Urban Design Review Panel Report

Project: 254 Argyle Avenue

Date: September 11, 2024

Response to Urban Design Review Panel Recommendations

UPDATED PROPOSAL
GROUND FLOOR

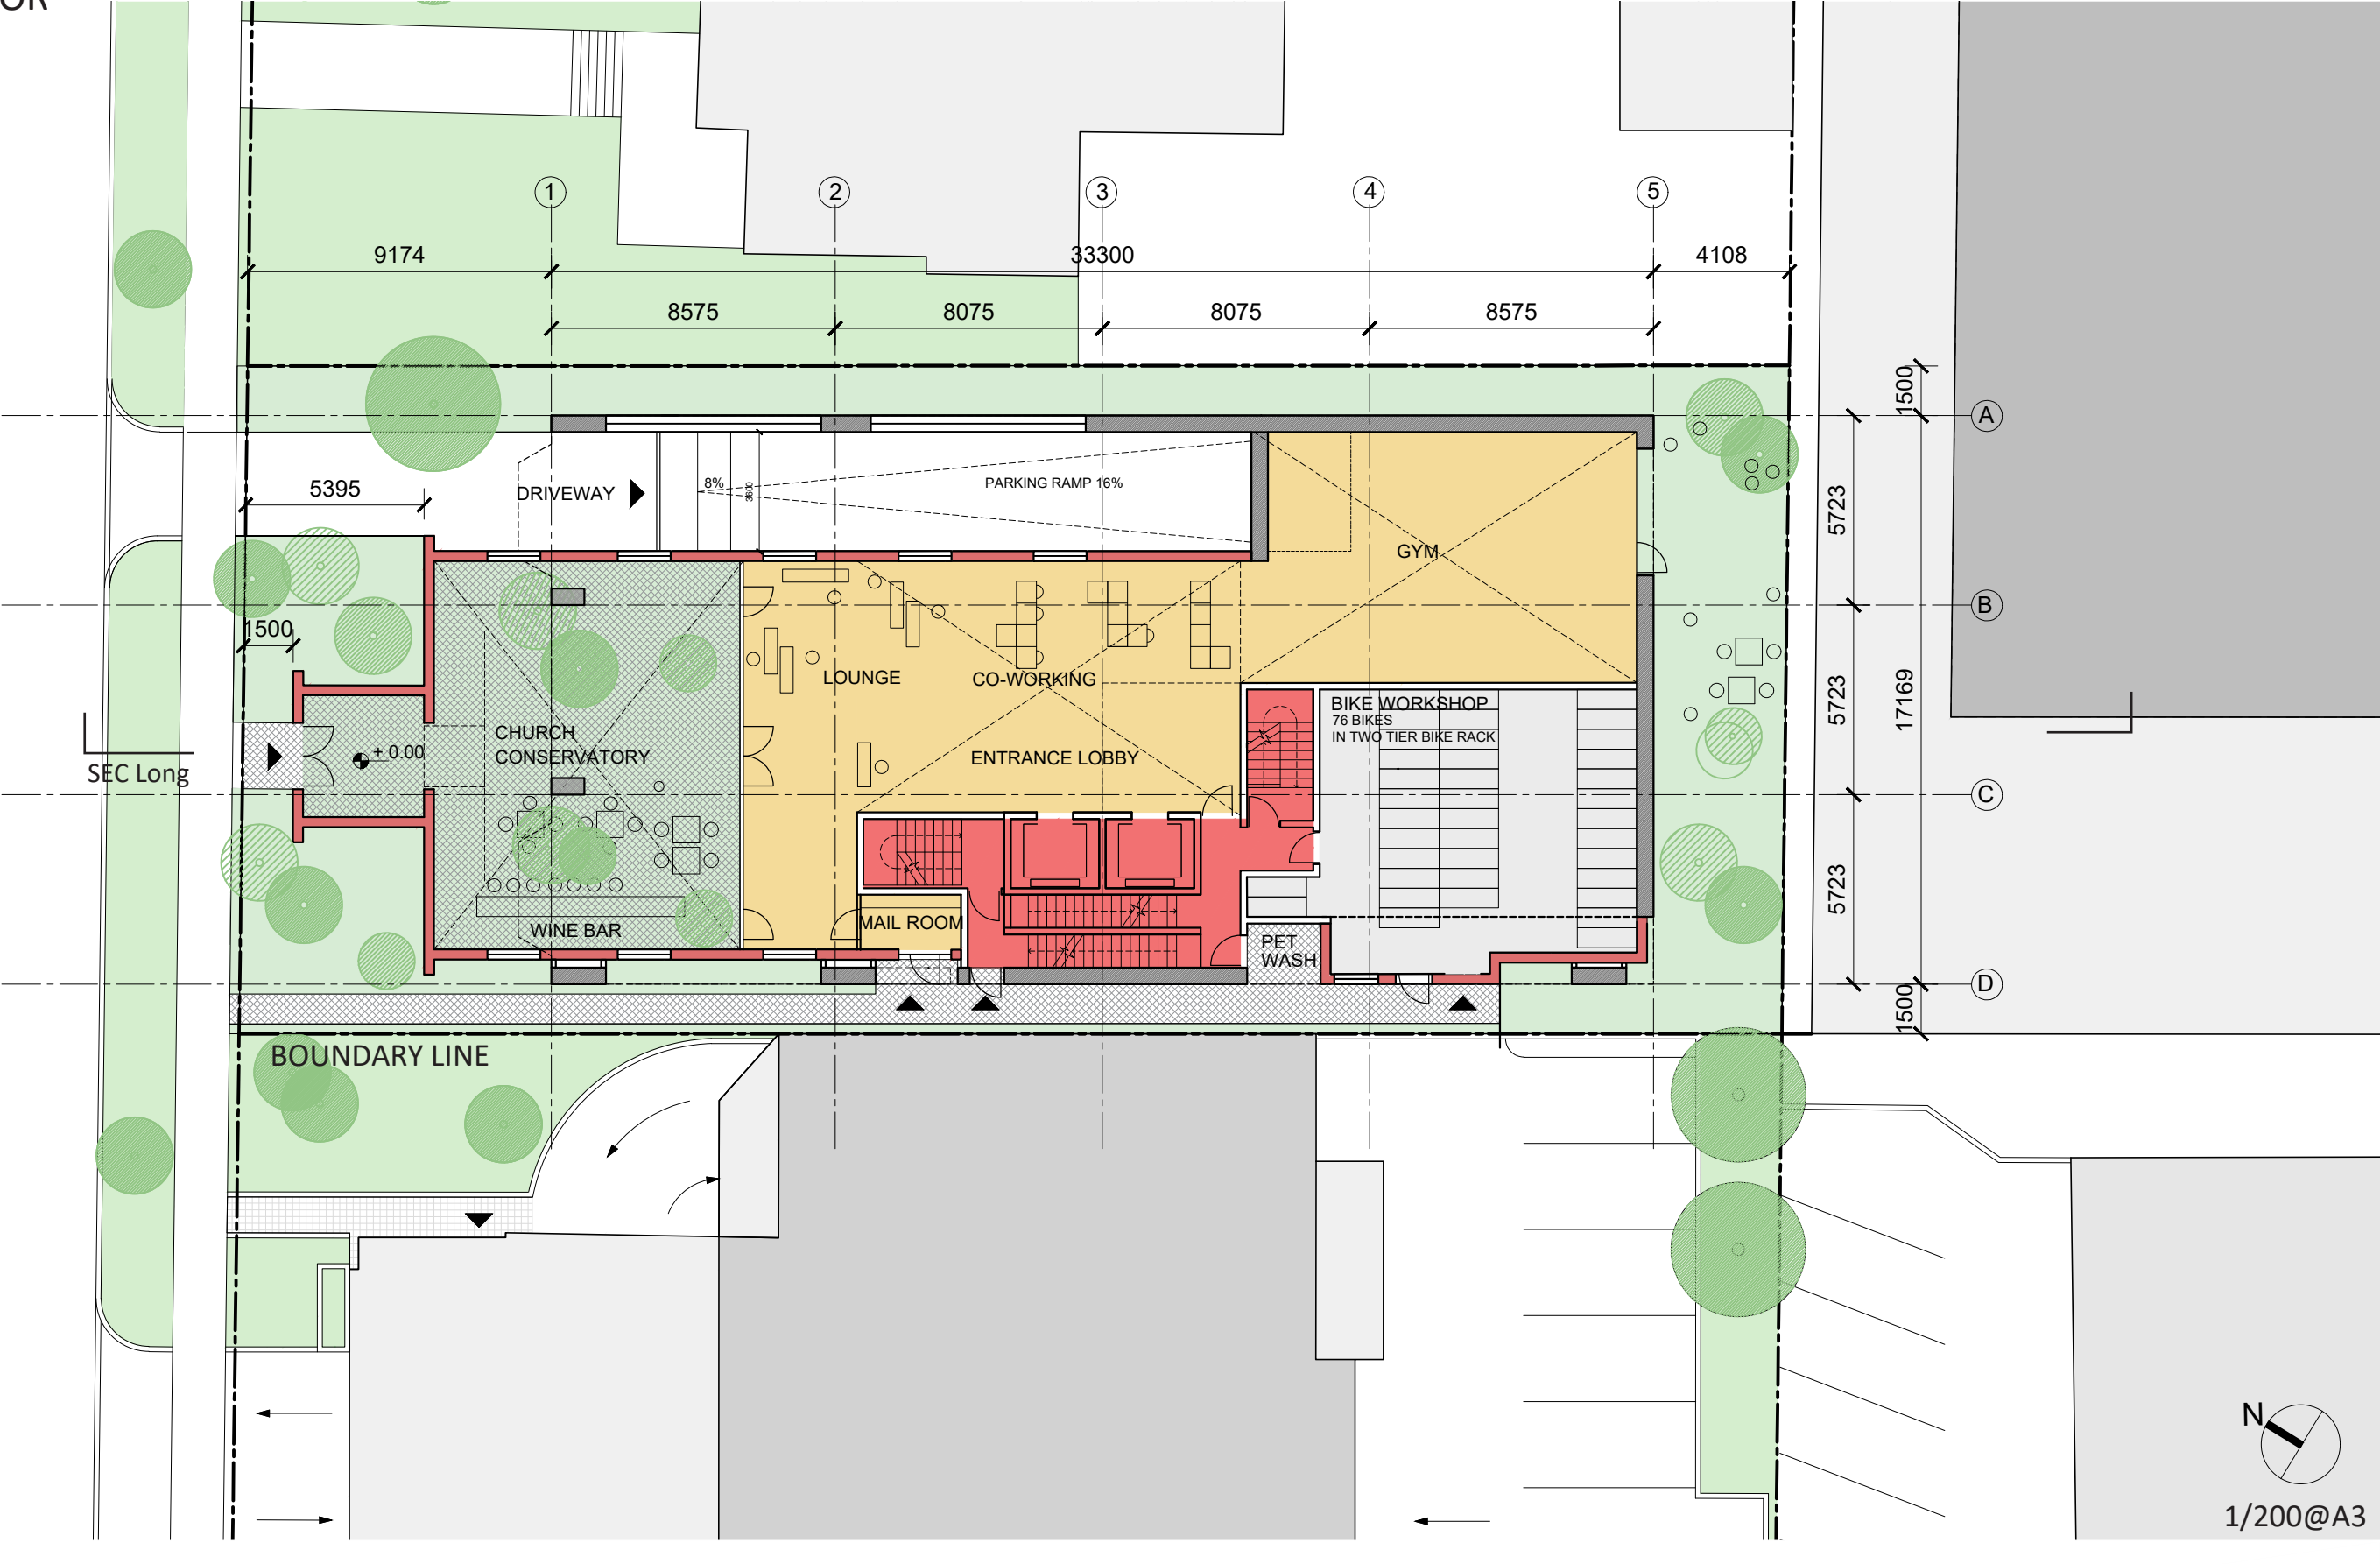
37. The Panel recommends retaining the heritage church up to gridline 2 on the ground floorplan (page 43), and not beyond.

38. The Panel recommends any structural requirements for the building above the church to be situated within the building envelope, rather than enveloping/entombing it.

- *For example, the intersection of gridlines D and 1, recommend bringing the tower column back completely within the heritage church, so as to not overbear it..*

Response: On the east elevation, the exterior wall of the church is retained in full, retaining and respecting the significance of the previous use of the site and character.

Response: The structure is now located behind the church walls.

NORTH ELEVATION - Material and colours options under study

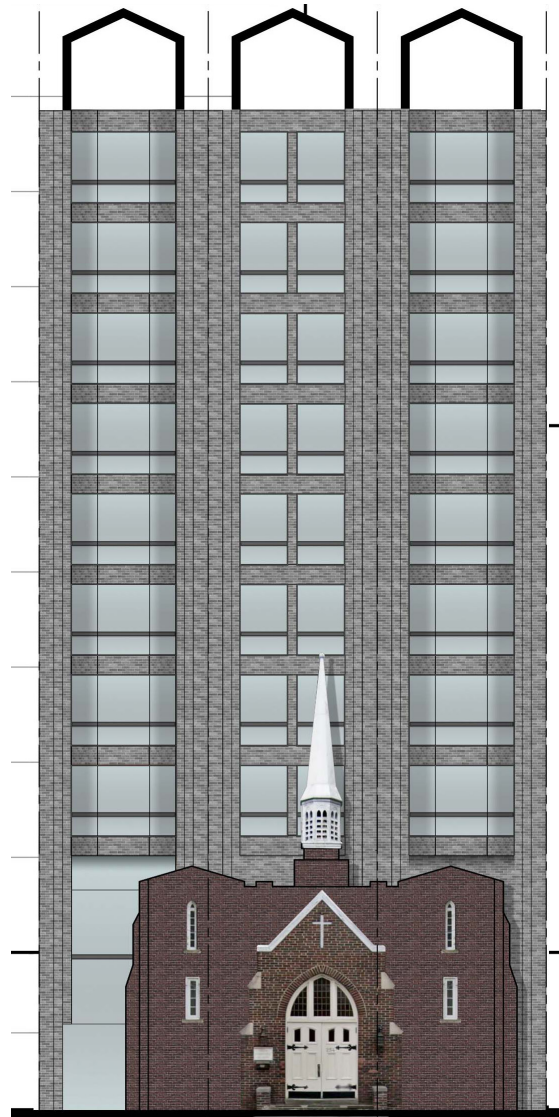
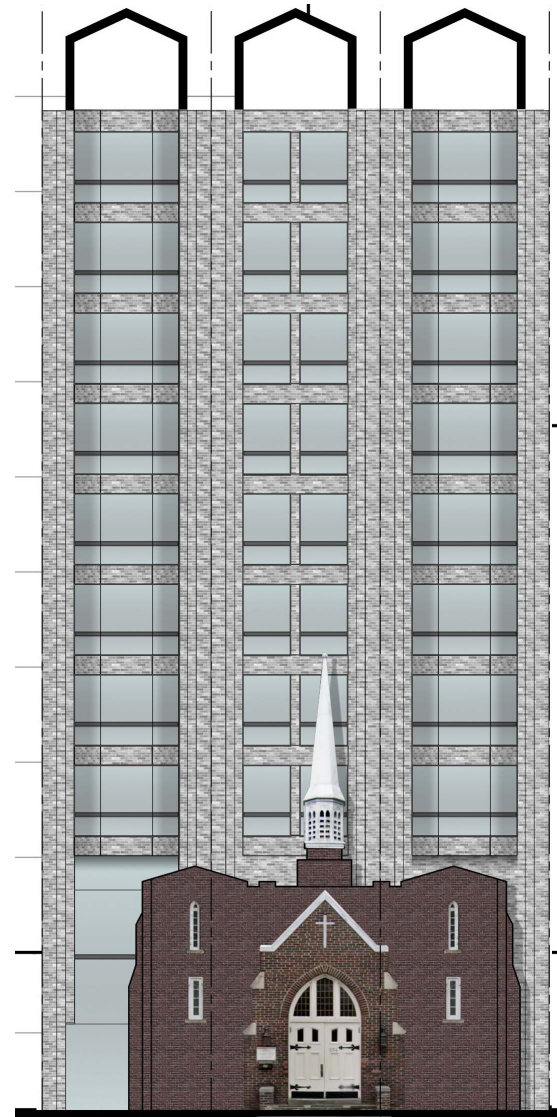
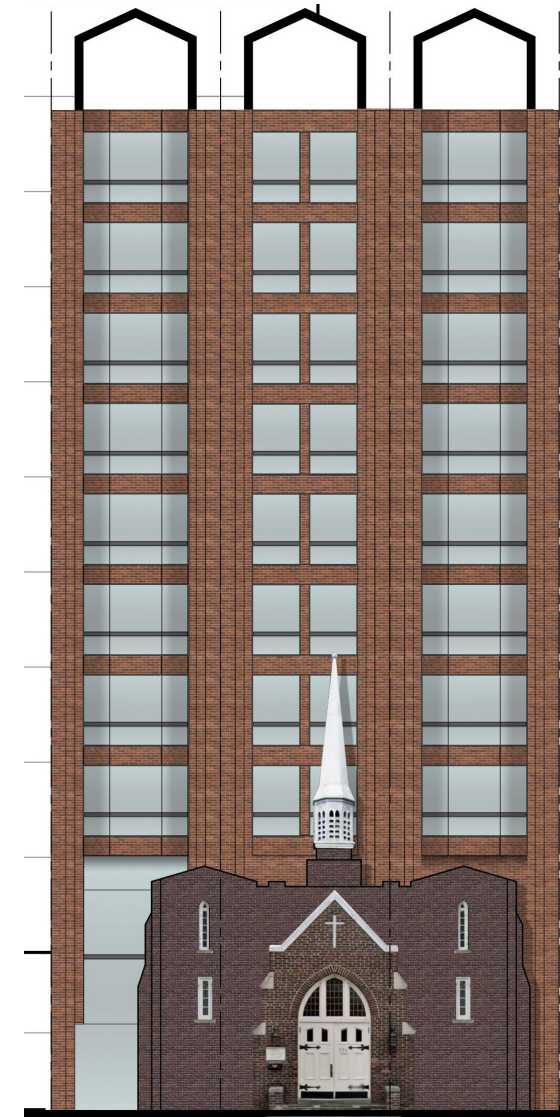
27. *The Panel has concerns with the white spire of the church losing its prominence in the grey brick colouration studies (page 56/60).*

- *Consider pursuing a darker masonry material that provides a background contrast to highlight the church and its spire.*

Response: The new material and coloration for the tower provides the contrast needed to behalf as a background for the church.
